## Product Change Notice (PCN)

PCN Number: PCN-0374226R-01

- CPE 1785

#### ❖ Appearance

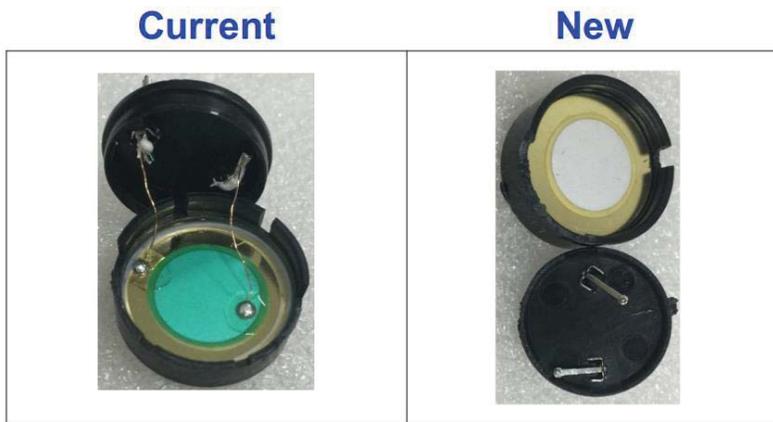
- Case markings Change from NORYL case to PBT
- Bottom notches going from 6 to 2

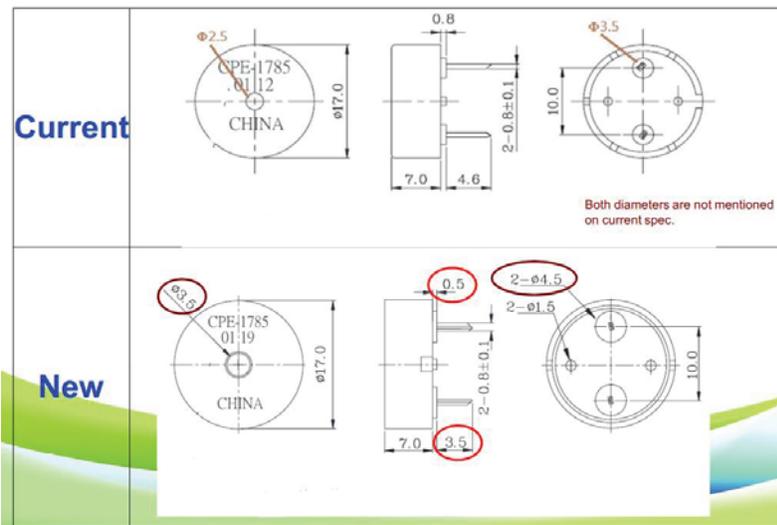
- ❖ Inside structure
  - Change from solder mask on inside to spring contact

- ❖ Pin length from 4.6mm to 3.5mm
